Mewbourne Oil Company requests approval to make the following changes to the approved APD (10400084788, 30-025-53219)

OPERATOR'S NAME:	MEWBOURNE OIL COMPANY
WELL NAME & NO.:	BUSHWOOD 21/16 FED COM 523H
APD ID:	10400084788
LOCATION:	Section 21, T.19 S., R.33 E. NMP.
COUNTY:	Lea County, New Mexico ▼

*Previously known as BUSHWOOD 21/16 B2FC FED COM 1H. Changes approved through engineering via **Sundry 2803559** on 8/22/2024. Any previous COAs not addressed within the updated COAs still apply.*

Figure 1. BOP diagram

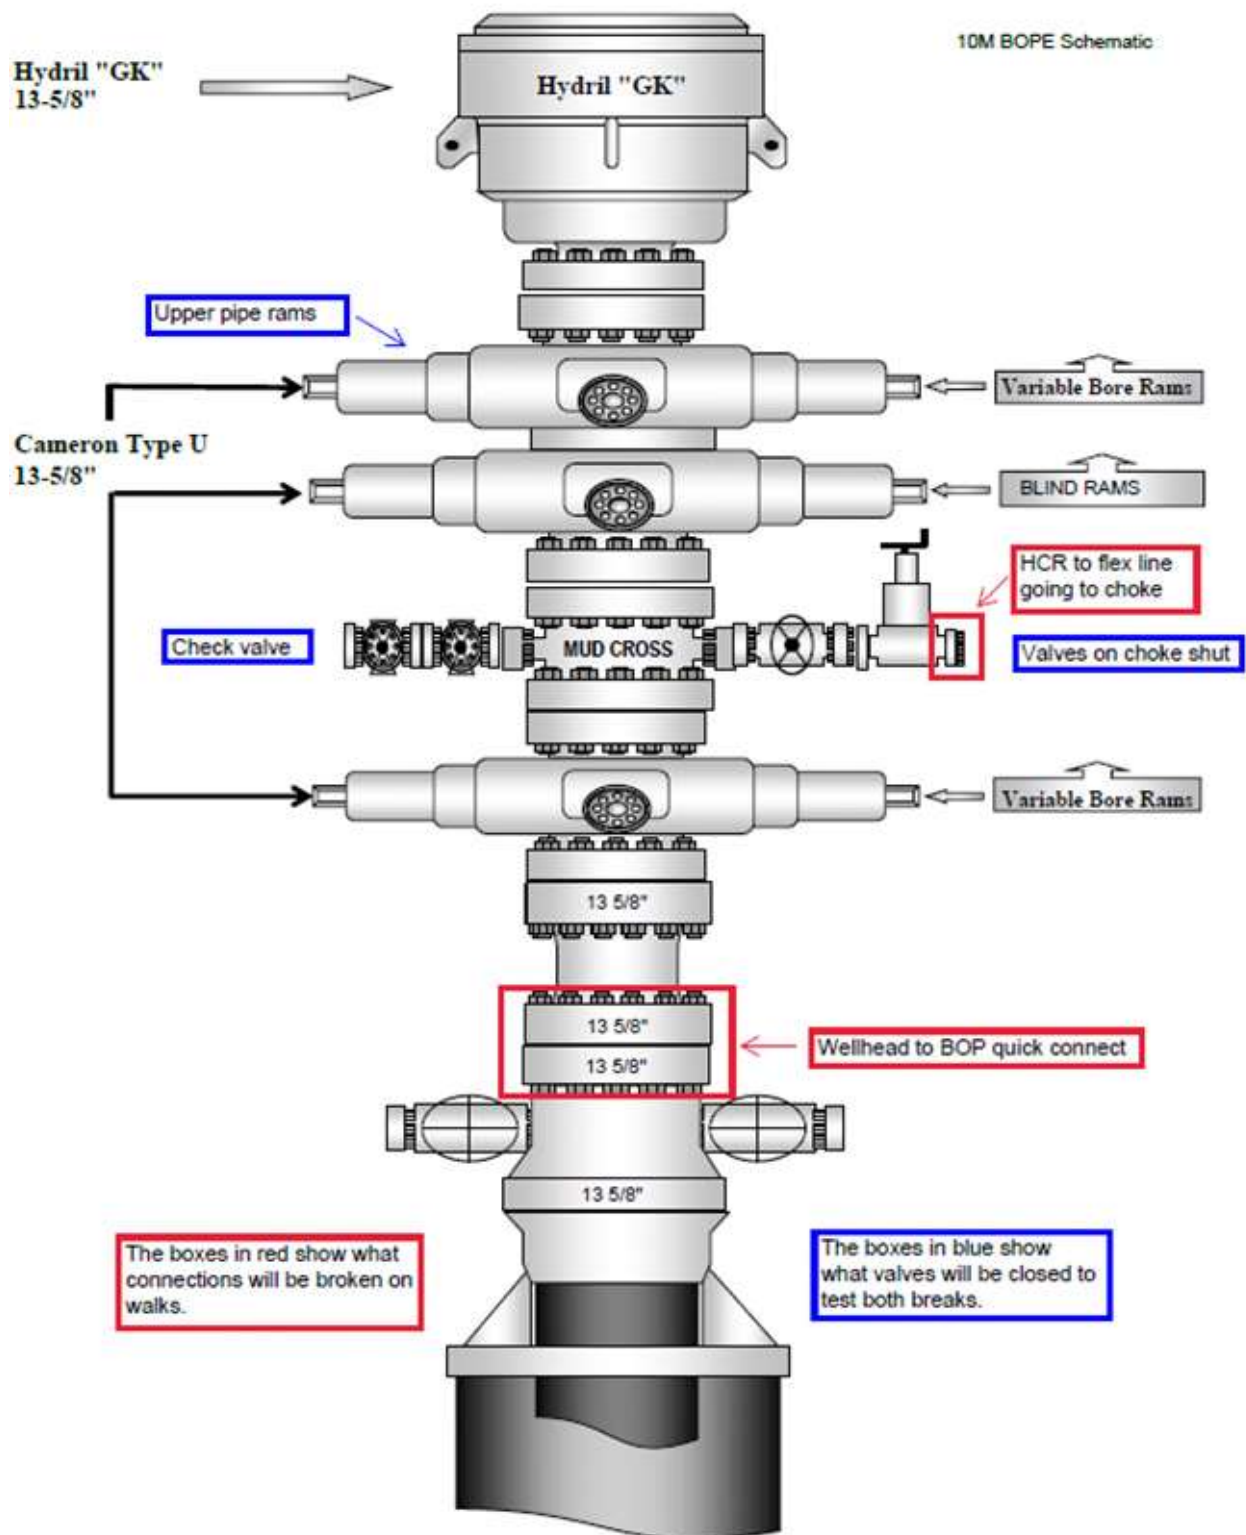
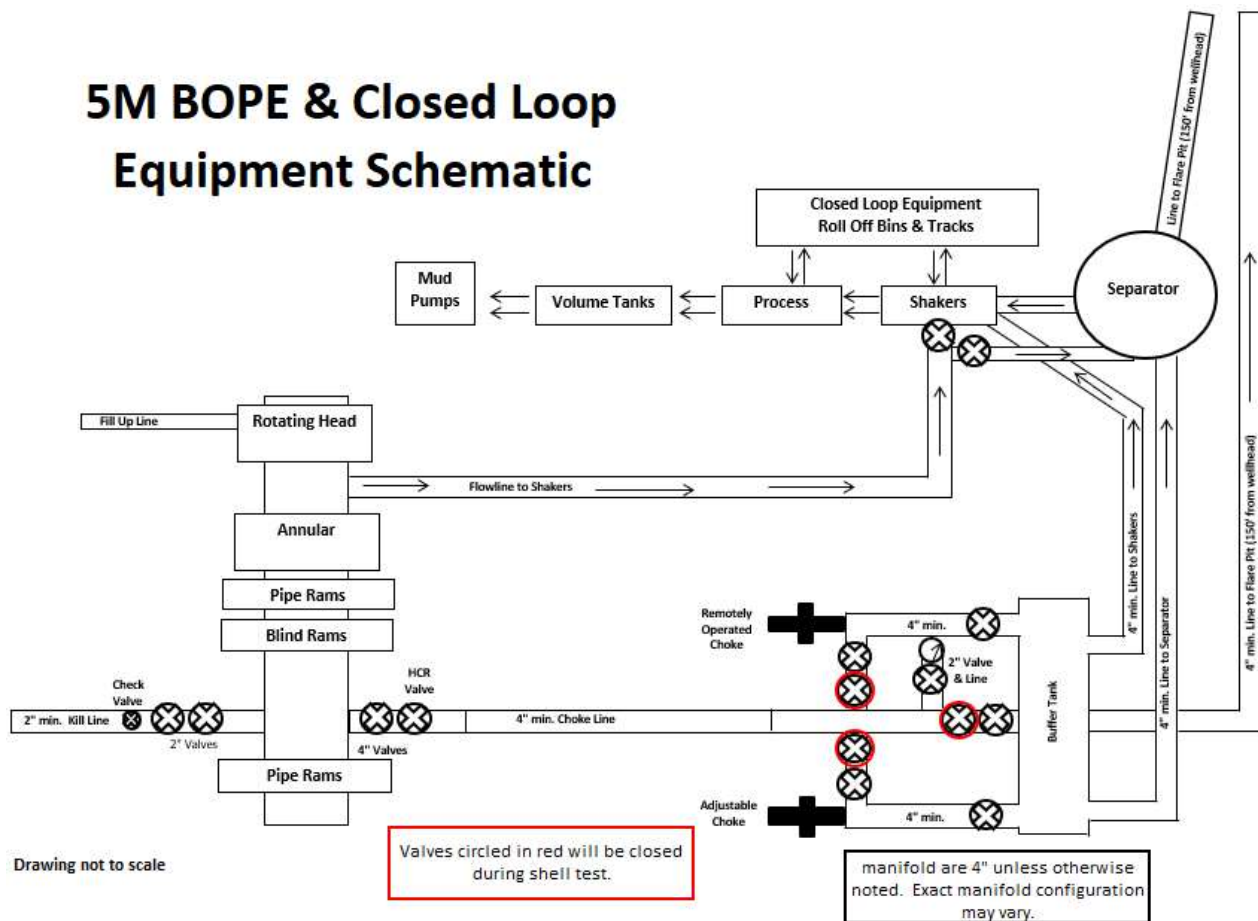
2. After the well section is secured and the well is confirmed to be static, the BOP will be disconnected from the wellhead and walked with the rig to another well on the pad. Two breaks on the BOPE will be made (Fig. 1).

9. A test will then be conducted against the upper pipe rams and choke, testing both breaks (Fig. 1 & 2).
10. The test will be held at 250 psi low and to the high value submitted in the APD, not to exceed 5000 psi.

Figure 5. Cactus 5M wellhead with BOP quick connect

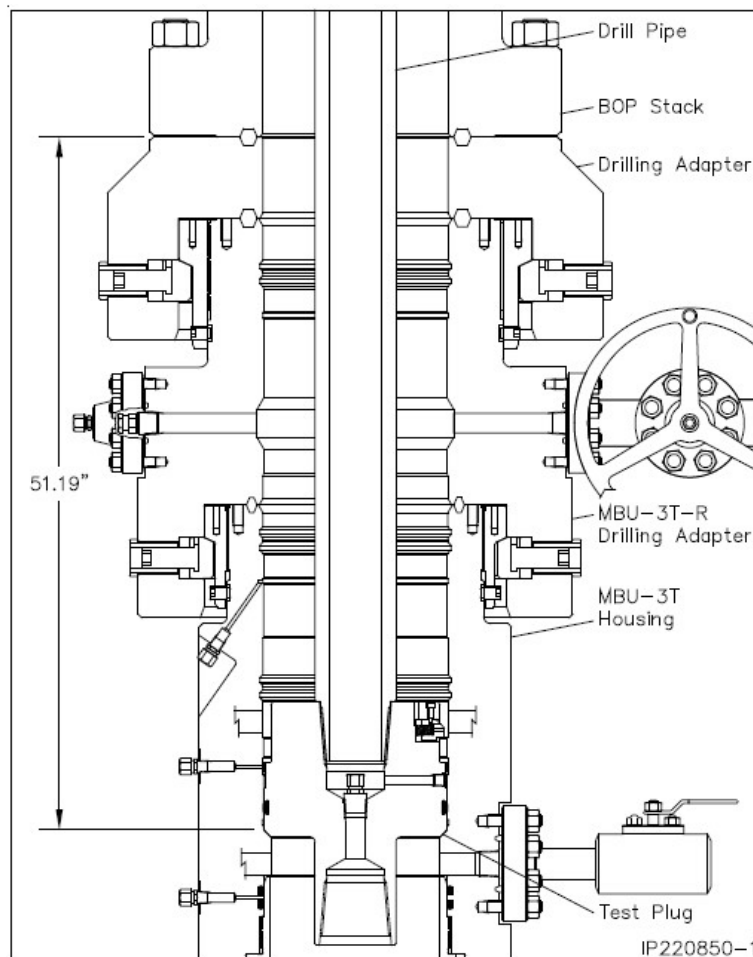
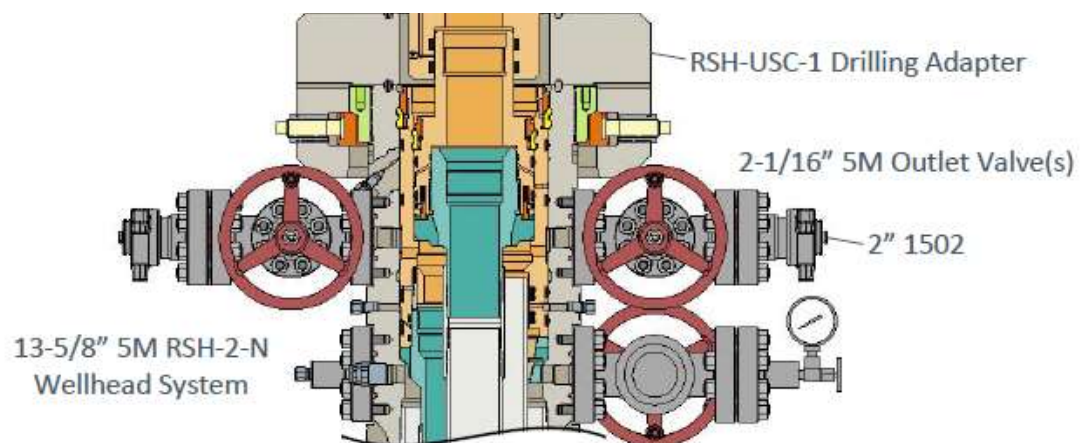
- Connection between the flex line and the HCR valve
 - Connection between the wellhead and the BOP quick connect (Fig. 5 & 6).
3. A capping flange will be installed after cementing per wellhead vendor procedure & casing pressure will be monitored via wellhead valve.

Figure 1. Cactus 13 3/8" 5M offline cementing tool. Pressure rating limited by the lesser of 5M tool rating or the 13 3/8" pup joint and casing.

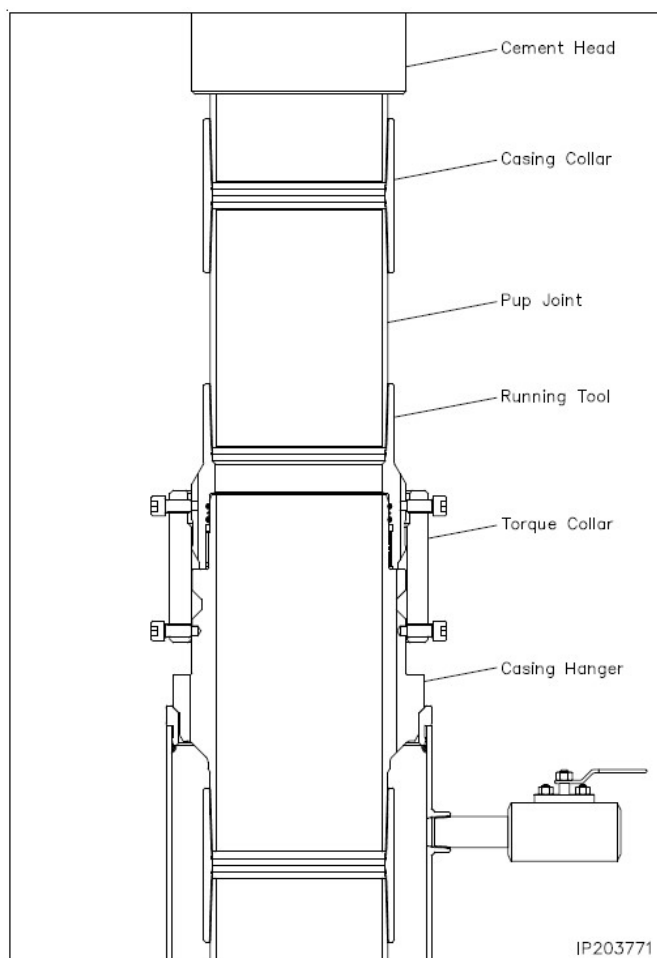
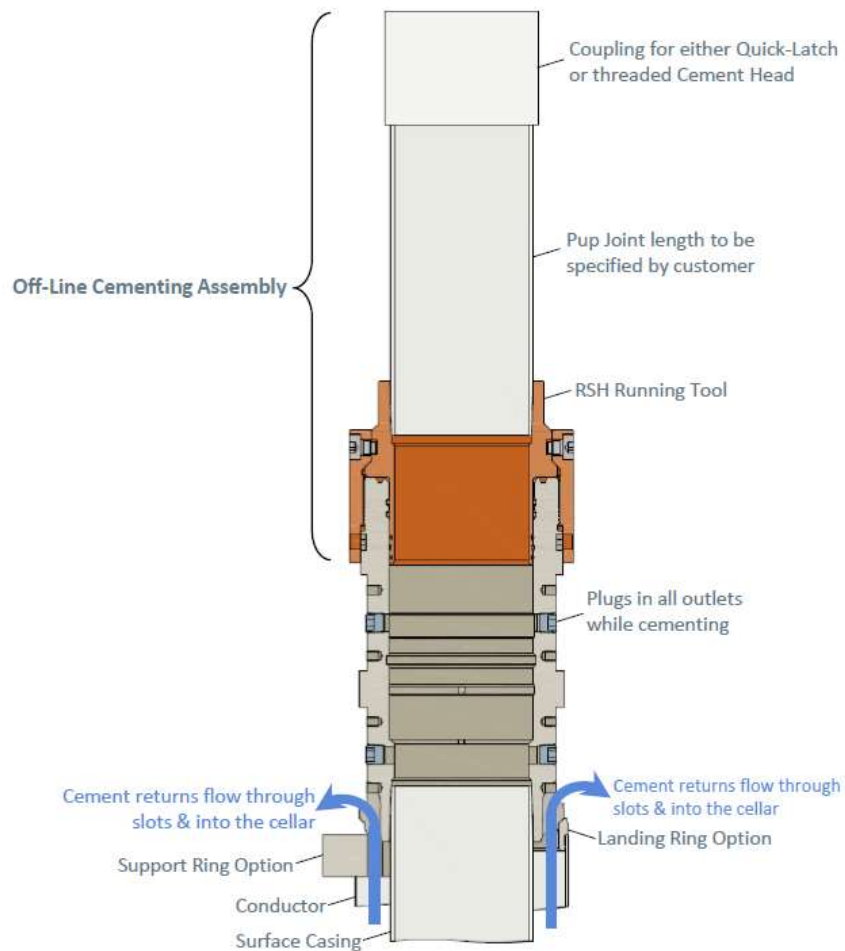
9. Make up offline cement tool with forklift per wellhead manufacturer (Fig. 1 & 2).
10. Make up cement head on top of offline cement tool with forklift.
